**From:** info@waipadc.govt.nz  
**Sent:** Friday, 30 September 2022 4:07 pm  
**To:** Policy Shared  
**Subject:** External Sender: Waipā District Plan - Plan Change Submission Form 5 - Jay El Limited

**This is a submission on the following proposed plan change to the Waipā District Plan**  
 #26 - Residential Zone Intensification

**RE: Submission on Plan Change 26 – Residential Zone Intensification**

### Point 3 – Zone Map 39 – Te Awamutu (East)

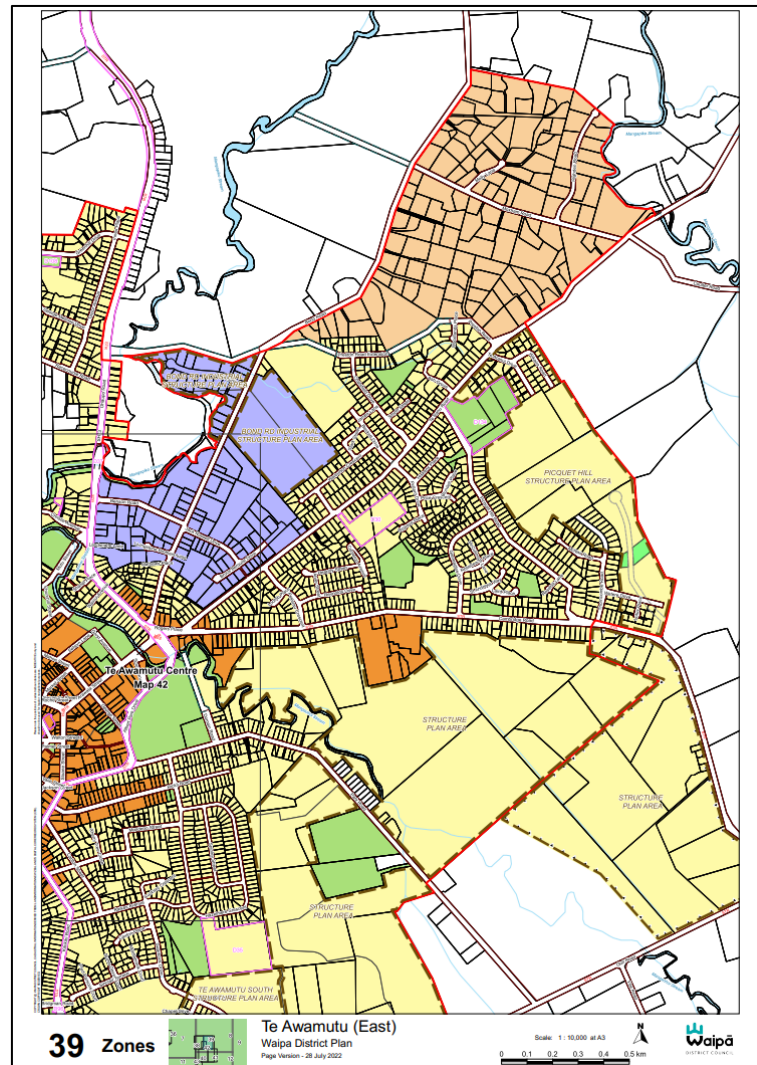
It is noted that there is a discrepancy between the Urban Limit on the proposed zoning map shown above and the extent of the zoning allowing residential development. Further, the above Urban Limit is not consistent with the location of it in the current zone and policy maps under the Operative District Plan, refer below. Namely, this discrepancy is located where the Urban Limit traverses the T11 growth cell. Please rectify this, which appears to be a simple mapping error.
